MEETING NOTES

Oslo Bay Apartments

Stormwater Pond

On-Site Walk

Figure: Excerpt From TIR for Reference

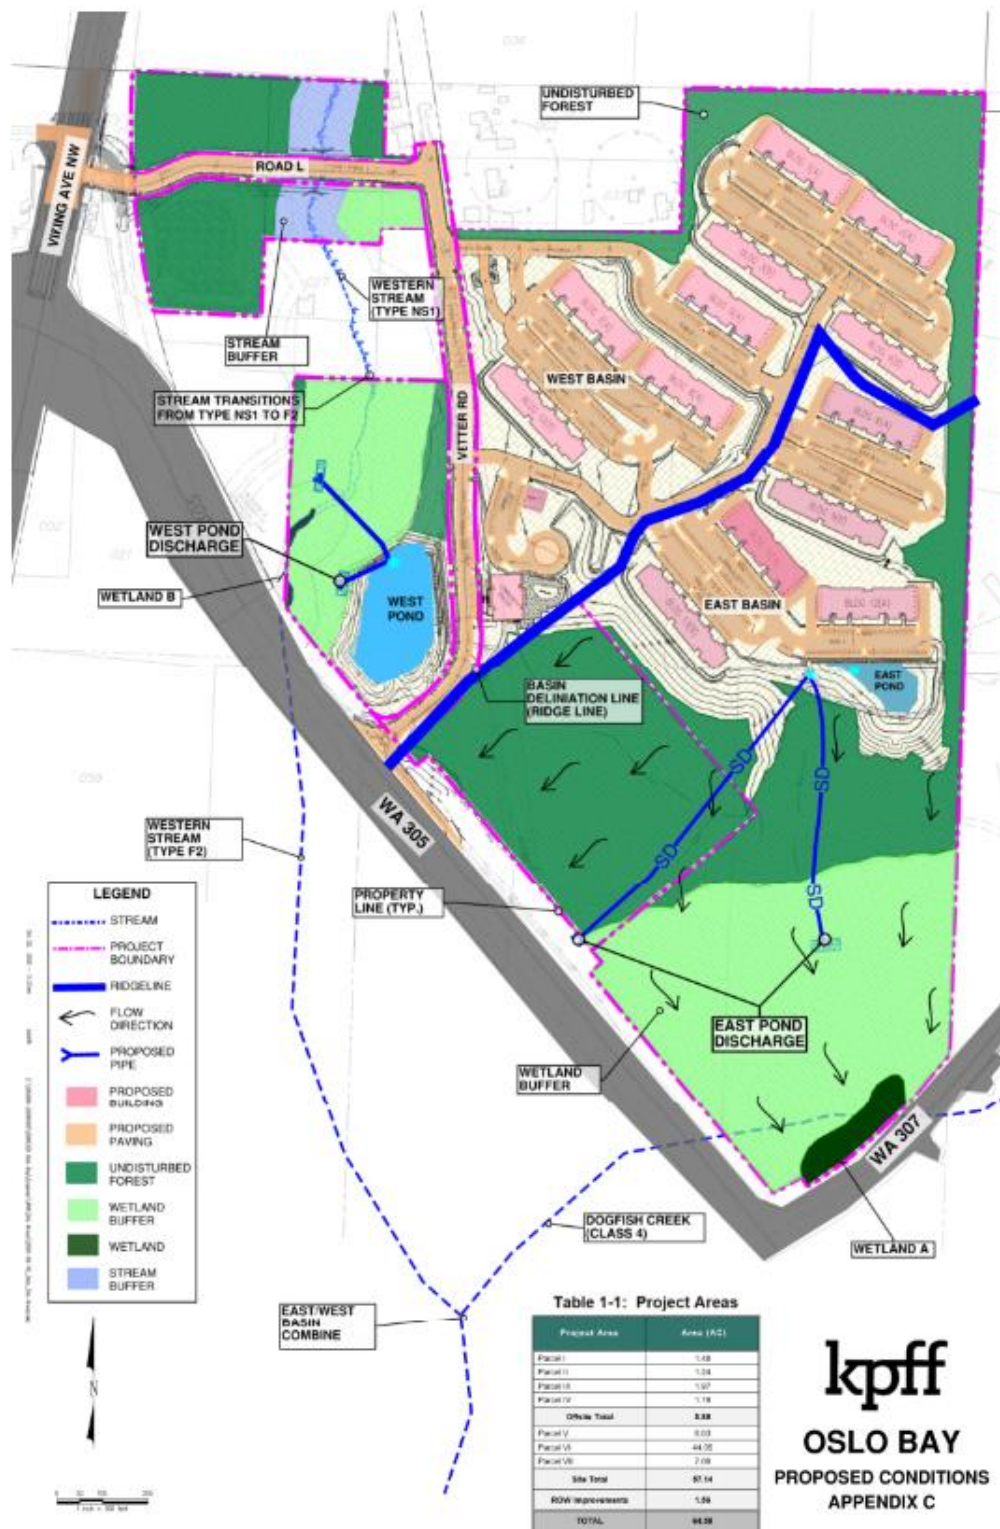
The development proposes two major stormwater mitigation facilities referred to simply as the "East Pond" and "West Pond". An exhibit from the project entitlement TIR is shown on the next page just for reference. Based on earlier discussions with City of Poulsbo Staff and with Suquamish Tribal Fisheries, we have developed a concept whereby high-frequency low flows from the pond outfall are directed to the headwater of the downstream natural drainage; were-as infrequent high-flows bypass to the man-made conveyance at the edge of SR-305. This is primarily what was reviewed in person on-site.
